DWG: KS-19594 DIALER ADDITION OF CURRENT LIMITING RESISTOR

CDS L-107098 A-

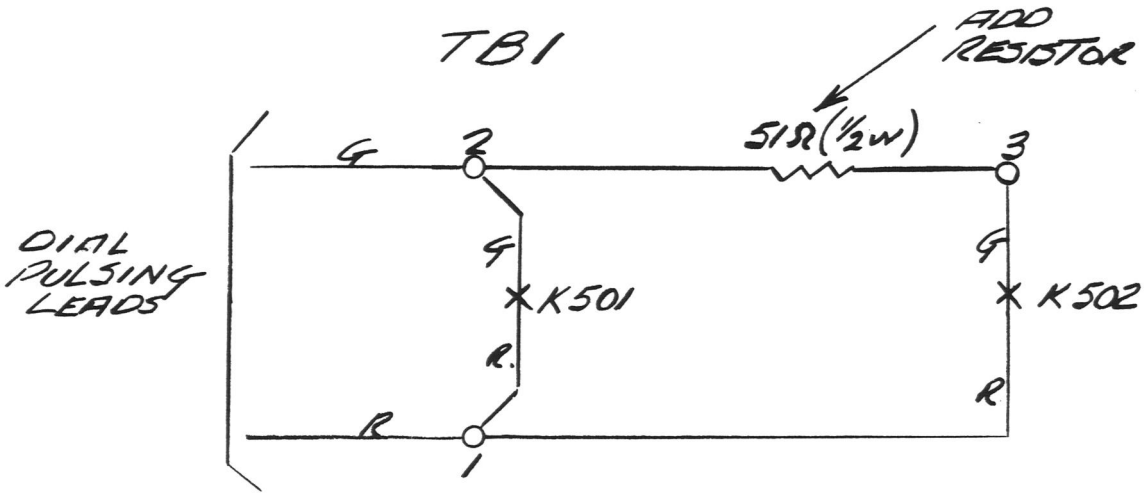
1. ALL KS-19594 DIALERS REPAIRED PER BSRS 451.919 SHALL CONFORM TO THIS DRAWING.
2. SOME RELAYS MANUFACTURED BY GRIGSBY-BARTON, INC. HAVE K501 AND K502 CONTACTS CONNECTED INTERNALLY (ONLY HAVE A SINGLE RED AND A SINGLE GREEN EXTERNAL LEAD). REPLACE THESE RELAYS WITH A TYPE WHICH HAS INDIVIDUAL CONTACT LEADS AS SHOWN ABOVE

ENGR HWE 8/2/68	ISSUE 1	ADDED NOTES #1 & #2.	OLS 12-17-68 ISSUE 2
DRAWN OLS 8/2/68
